Office Action Summary

10/596,250

DURTH ET AL.

Claims 13-22 and 24 are rejected under 35 U.S.C. 102(b) as being anticipated by Boy, Patent No. 4,769,736.

Fig. 3 Extracted from US 4769736

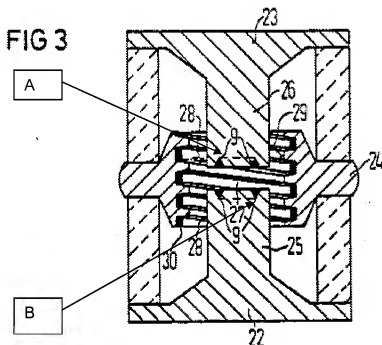
With respect to claim 13, Boy discloses an overvoltage protection means, comprising: a first electrode [Fig. 3; 22; col. 4 lines 64-65], a second electrode [Fig. 3; 23; col. 4 lines 64-65], a breakdown spark gap [Fig. 3; 27; 28; col. 4 lines 63-66] having a discharge space formed between the electrodes [Fig. 3; between the electrodes 22 and 23; col. 4 lines 63-66], an arc forming between the electrodes within the discharge space when the breakdown spark gap is ignited [col. 1 lines 35-47], and a housing [col. 5 lines 59-60] which holds the electrodes [Fig. 3; 22, 23], wherein the discharge space [Fig. 3; 27, 28] is configured in a manner which runs at least one of partially transversely and partially opposite a direction of an electrical field of a prevailing line voltage so that a distance to be overcome by the arc between the two electrodes has a component that is transverse relative said direction of the electrical field as disclosed; and wherein the discharge space extends from a radially outer area of the face of one of the electrodes [A; see the extracted Fig. 3 below; the discharge space coming from point A of electrode 23] to a diametrically opposite radially outer area of the face of the other of the

electrodes [B; see the extracted Fig. 3 below; the discharge space coming at point B of electrode 22].

With respect to claim 14, Boy discloses an overvoltage protection means wherein the discharge space has at least three regions, a first region of which is connected to the first electrode [Fig. 3; the first electrode 22 is connected to the discharge gap 28 at the lower left side of the electrode 22 as shown], a second region of which is connected to the second electrode [Fig. 3; the second electrode 23 is connected to the discharge gap 28 at the upper left side of the electrode 23] and a third region of which is connected between the first region and the second region [Fig. 3; subsidiary discharge gap 27 is connected between the first region and the second region].

With respect to claim 15, Boy discloses that the third region runs essentially perpendicularly to the direction of the electrical field of the prevailing line voltage [Fig. 3; the third region of discharge path 27 is arranged perpendicular to the electric field].

With respect to claim 16, Boy discloses that the third region runs partially obliquely to the direction of the electric field of the prevailing line voltage [Fig. 3; the third region 27 runs partially obliquely, which is sloping or joining something at an angle that is not a right angle].

With respect to claim 17, Boy discloses the third region runs partially opposite the direction of the electric field of the prevailing line voltage [Fig. 3; when the third region 27 runs upward, it runs partially opposite the direction of the electric field].

Examiner points out that Boy reads on this limitation of "wherein the discharge space...of the other of the electrodes." [See above extract Fig. 3 and rejection]
